TENNESSEE VALLEY AUTHORITY
River System Operations & Environment
River Operations

Hydrothermal Modeling of Browns Ferry Nuclear Plant With Units 1, 2, and 3 at Extended Power Uprate

WR2005-1-67-135

Figure 11. Computed and Measured River Temperature Upstream of BFN for 1993

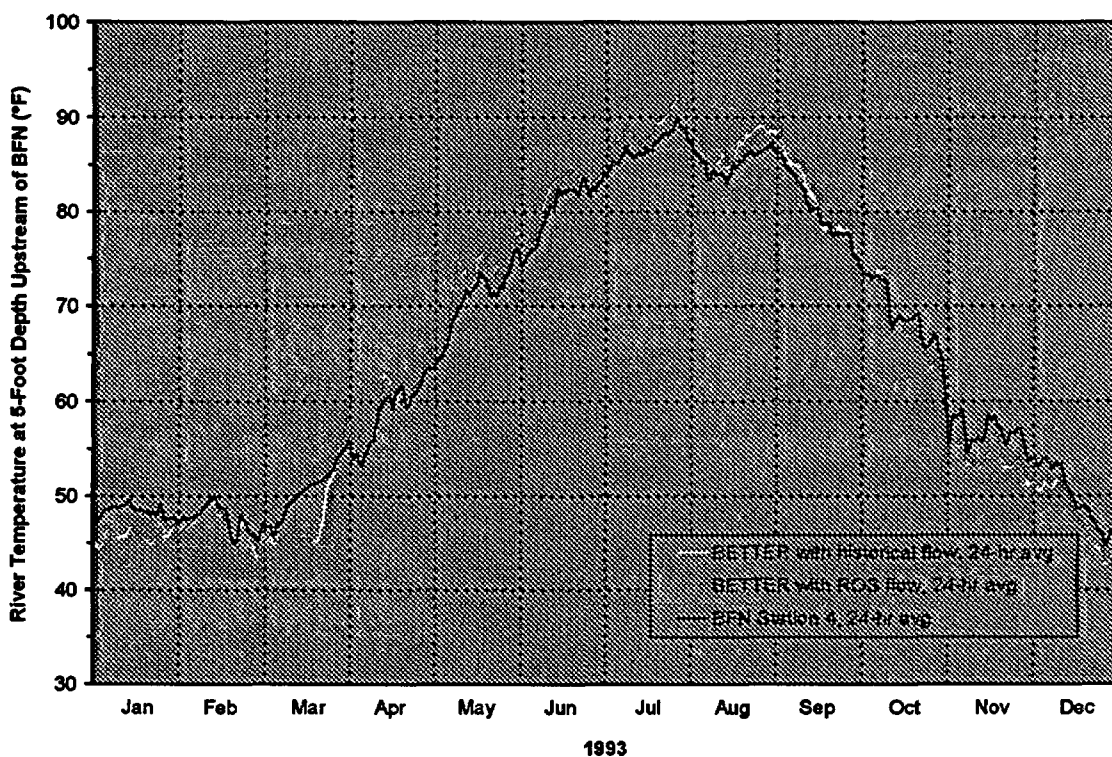
II.3.2 The response to Question 11, regarding Figure 11 and the effects of ROS releases on upstream river temperatures at the hourly scale, should be included in the report.

Figure 23. Computed vs. Measured Temperatures for Two-Unit Operation for Summer 2002

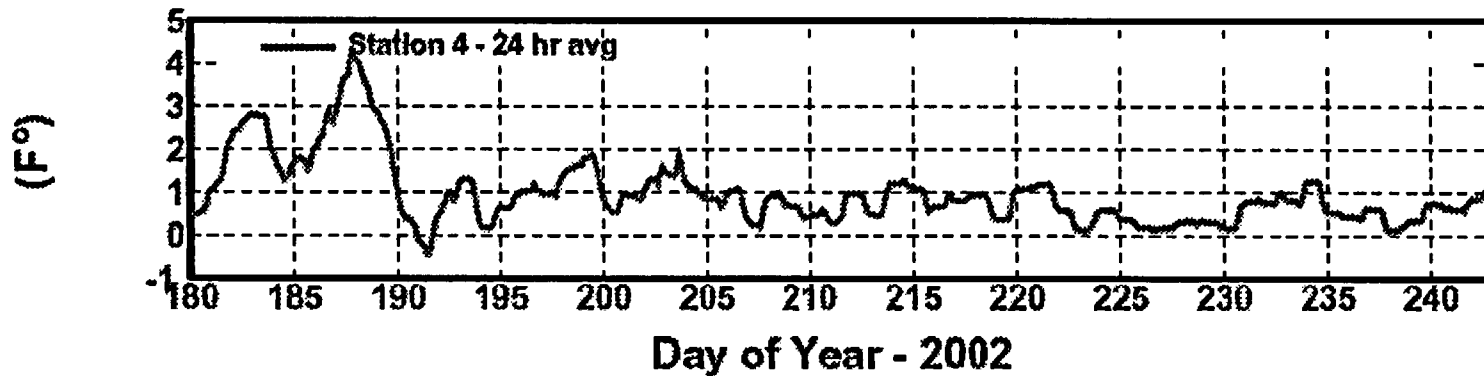
II.1.3 The rather poor agreement between the measured and computed downstream temperatures from days 206 to 218 in 2002, Figure 23, should be commented on in the text. Something else must have been going on.

Figure 25. Baseline (Case 0) Results for BFN Simulations

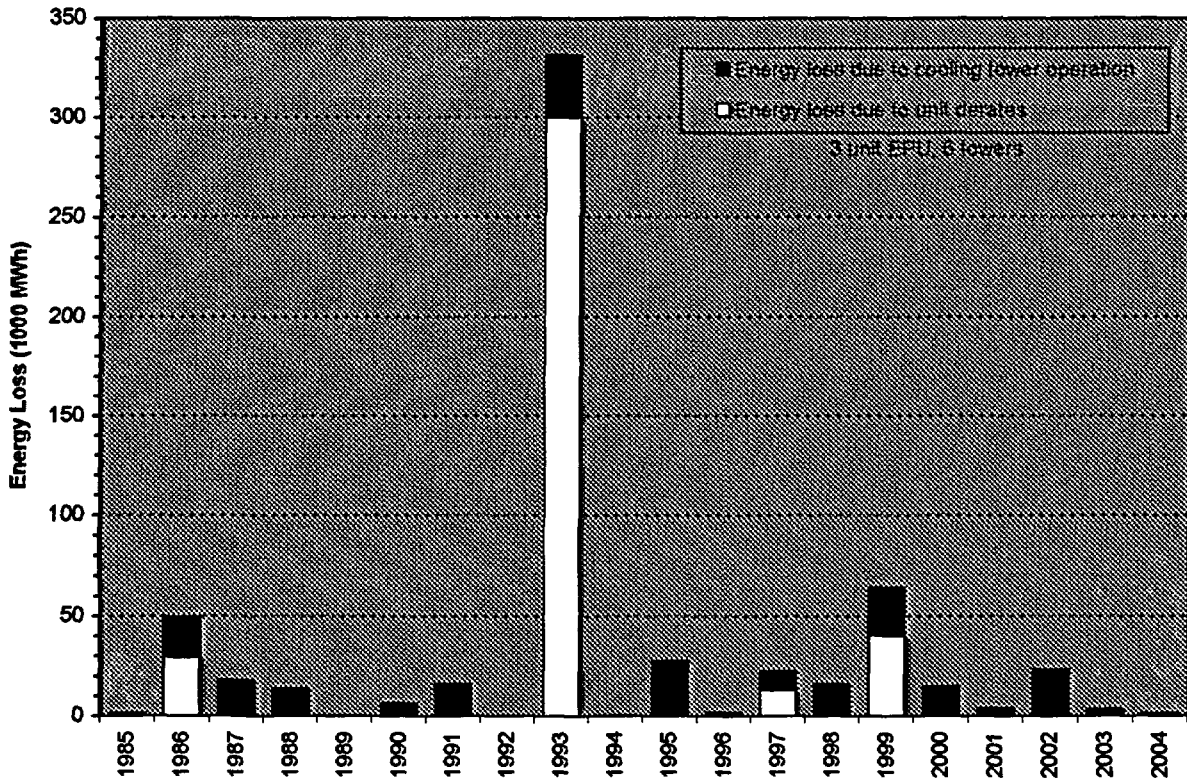
II.7.1 The Case 0 results as depicted in Figure 25 are not consistent with Table 9 from which they were drawn. However these same results as depicted in Figures 31, 32, and 33 appear to be correct.

Figure 26. BFN Operation for 1993

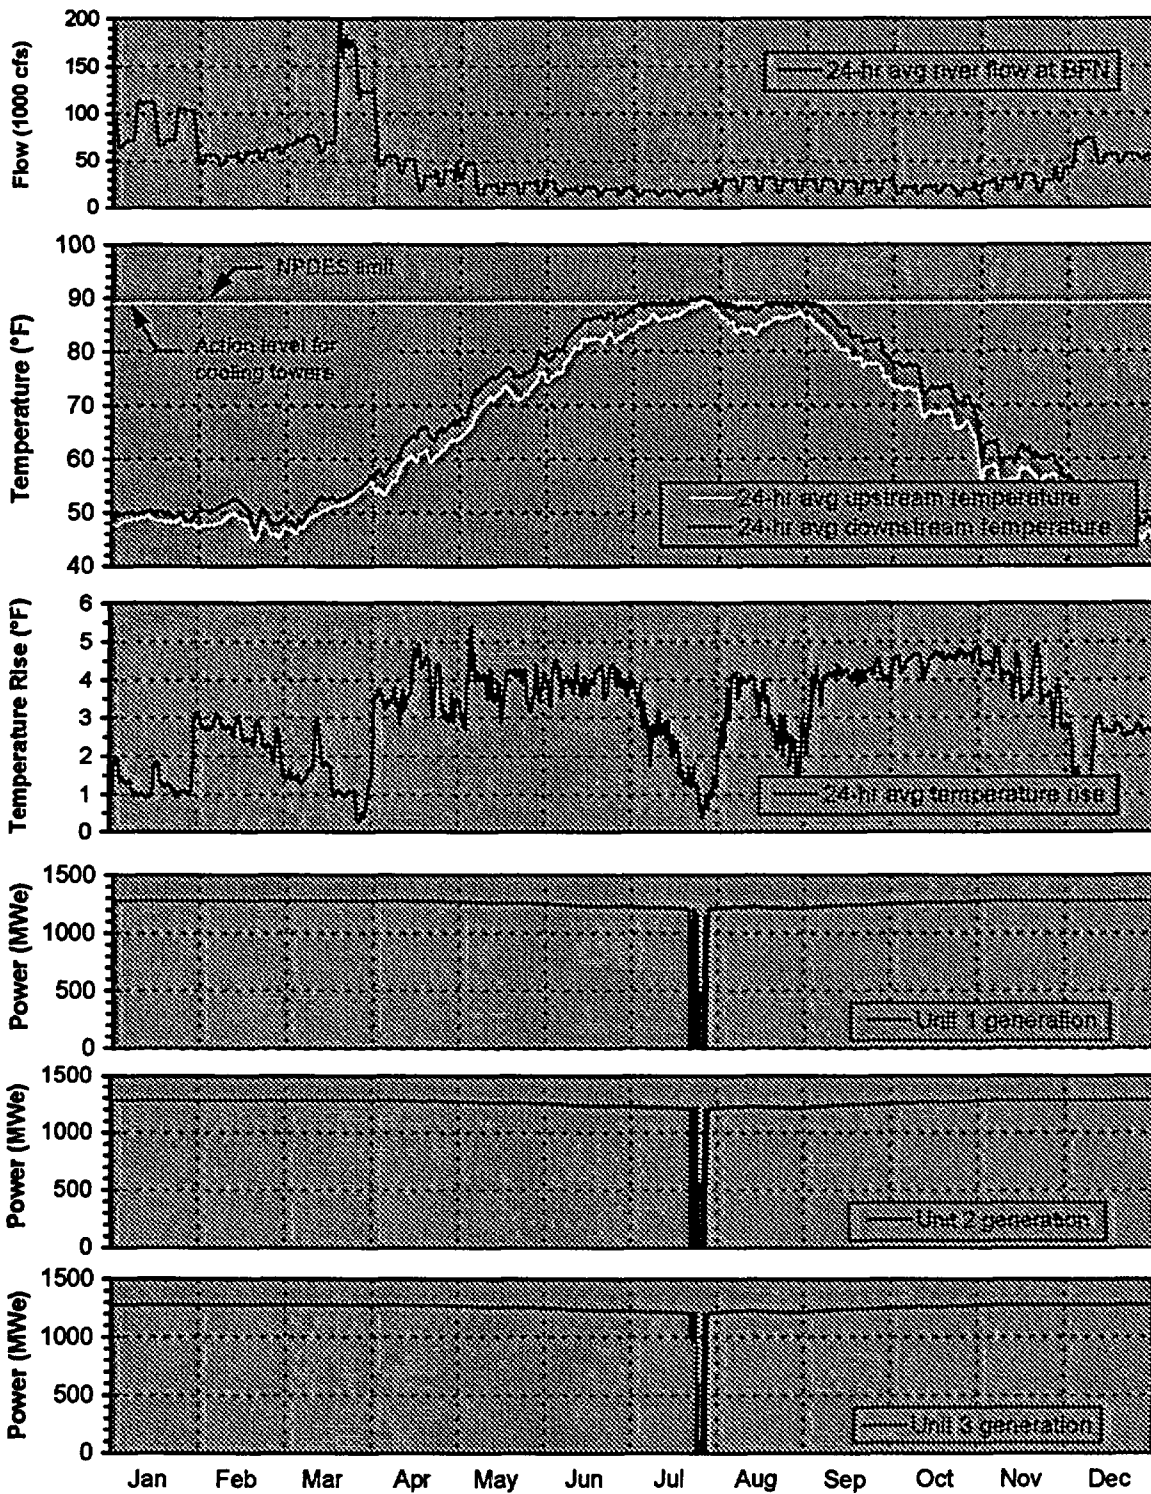
II.7.2 In Figures 26 and 27, one can infer when towers were in operation by the changes in the temperature rise. Nonetheless, it would be interesting to show tower operation directly, as the text refers to the timing of tower operation as well as unit derates. This would add one panel to the Figures, but it would make the Figures even more complete and informative.

Figure 27. BFN Operation for Late July 1993

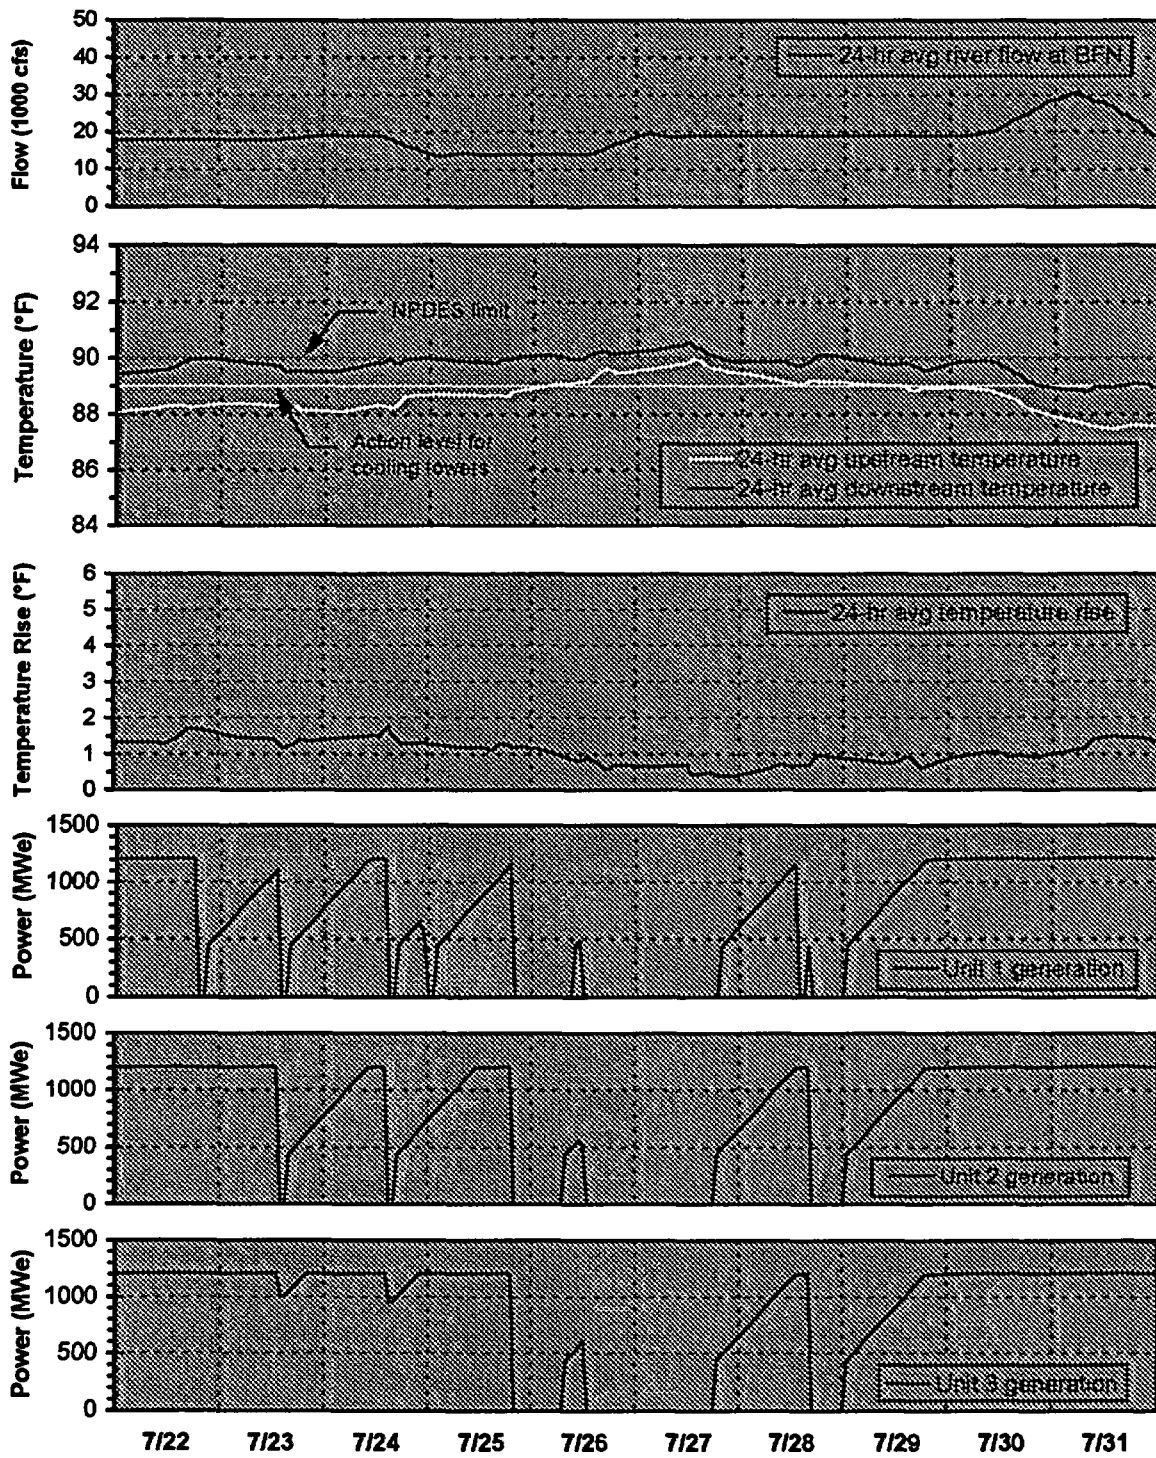
II.1.5 Figure 27 seems to suggest that the model predicted an apparent NPDES permit violation on 26-27 July of 1993 – yet in the model the units were shut down. There is

Figure 29. Effect of Condenser Cleanliness Factor on Condenser Temperature Rise

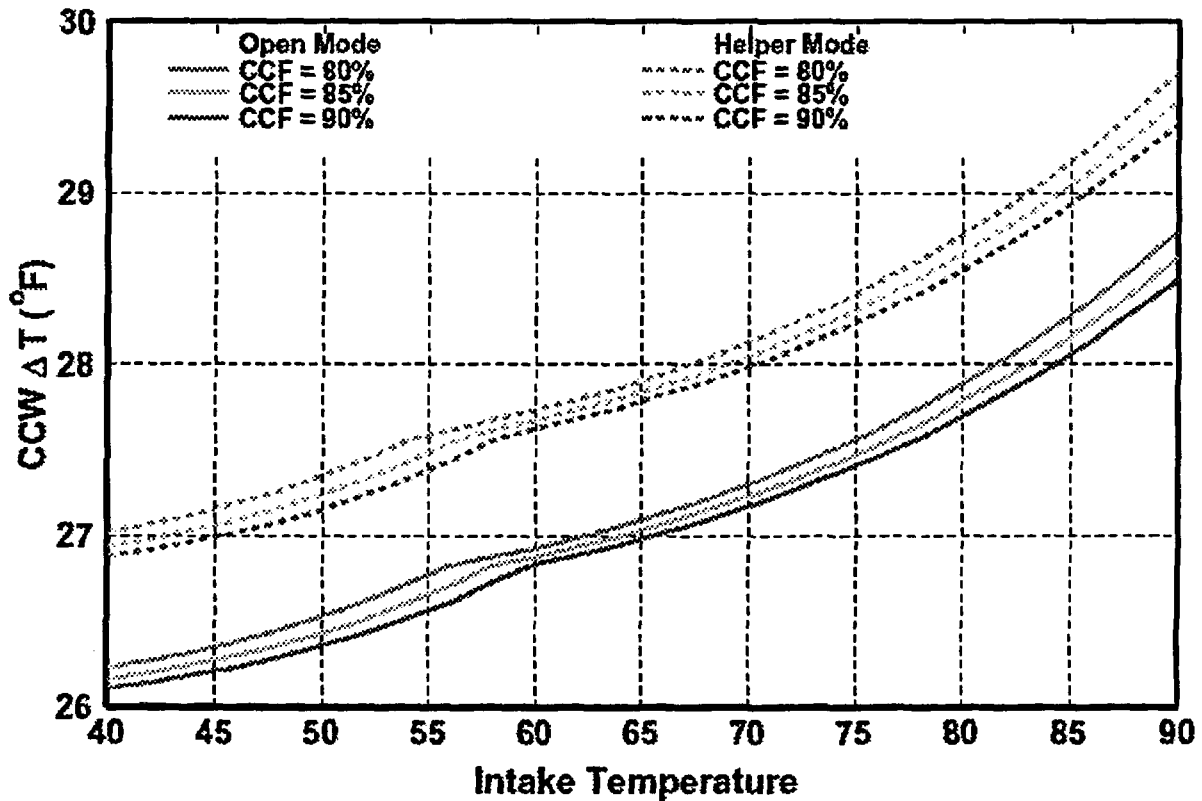
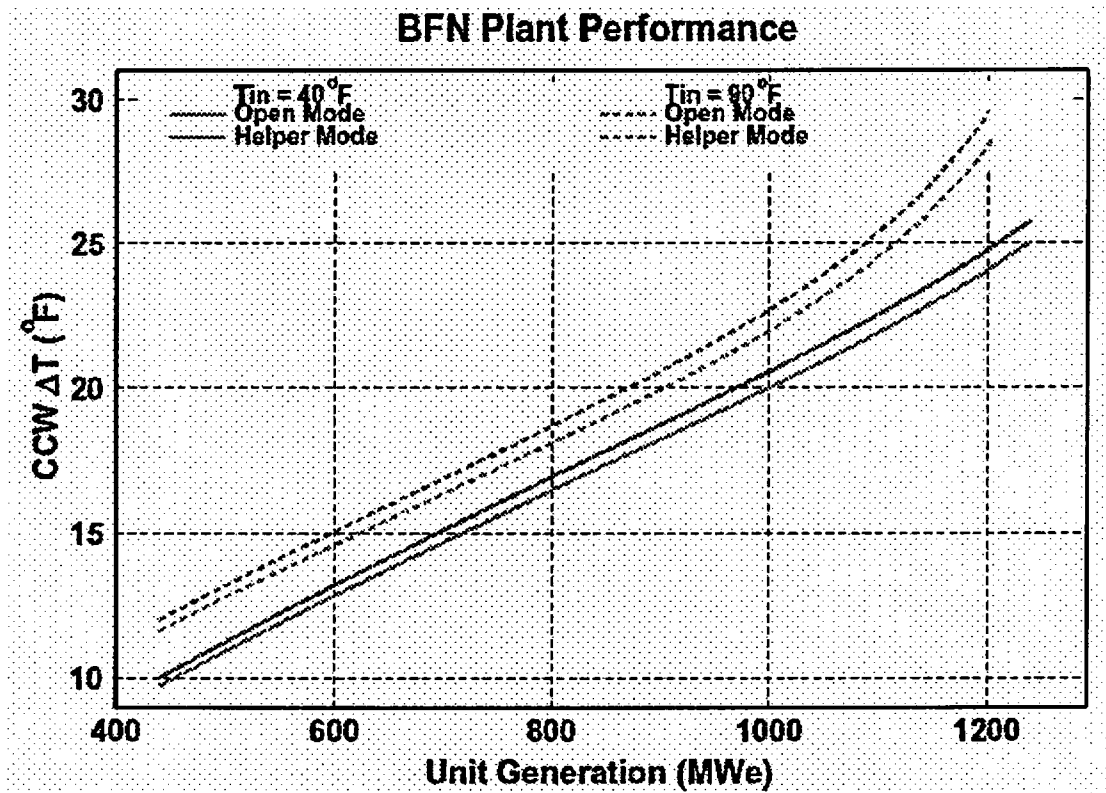
II.3.1 Figure 29 has some strange kinks in the condenser curves that do not appear to be reflected in Figure 16. These are not the same presentation, but it would be helpful if the authors could explain the anomalies in the curves, if in fact they are anomalies.

16. Page 30, Figure 16. Does the higher CCW ΔT for helper mode simply reflect the reduced CCW flowrate, or am I missing something else?

The reduction in CCW flow is due to the increased losses associated with passing the water through the conduits to the cooling tower warm water channel (e.g., see Figure 5 and Figure 6). This brings to the attention another feature of the model that needs to be better emphasized in the report—that is, the hydrothermal model does not determine the detailed hydraulic characteristics of the flow throughout the CCW conduits and channels (e.g., HGL and EGL).
